RECALL CAMPAIGN BULLETIN

Reference:
NTB06-083

VOLUNTARY RECALL CAMPAIGN 2007 VERSA; BRAKE FLUID RESERVOIR CAP

CAMPAIGN I.D. / NHTSA # PB024 / 06V-348
APPLIED VEHICLE: 2007 Versa (C11)
APPLIED VINS: 3N1BC13E(*)7L 350001 - 369667

Instructions For Versa Brake Fluid Reservoir Cap Installation

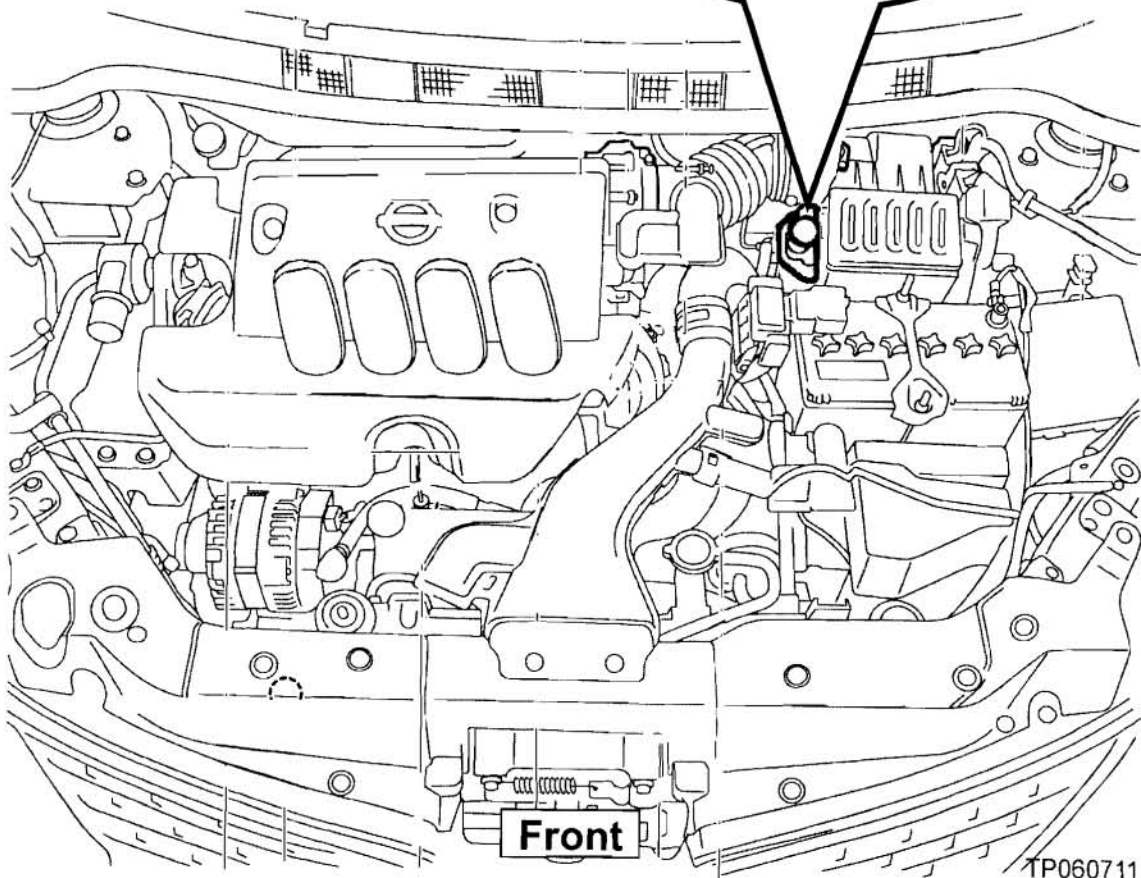
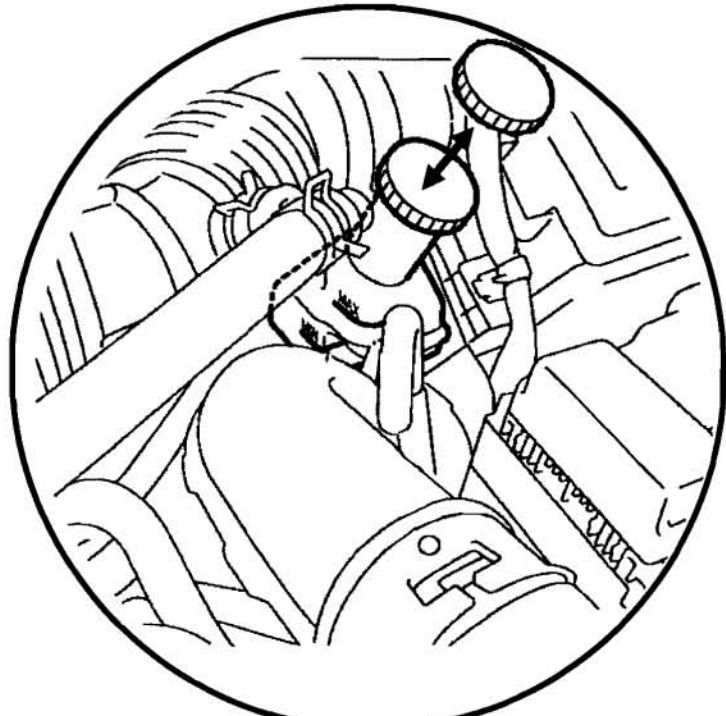
The wording embossed on the brake fluid reservoir cap is incorrect and does not contain the statement "WARNING CLEAN FILLER CAP BEFORE REMOVING. USE ONLY DOT3 BRAKE FLUID FROM A SEALED CONTAINER." as required by FMVSS No. 135. To correct this condition, Nissan is conducting a Voluntary Recall Campaign to replace the existing brake fluid reservoir cap with a new brake fluid reservoir cap containing the required labeling.

1. Use a clean cloth to wipe clean the brake reservoir cap and the area around it.
2. Turn the cap counter-clockwise to remove it.
3. Install the new cap. Turn it clockwise until it stops.
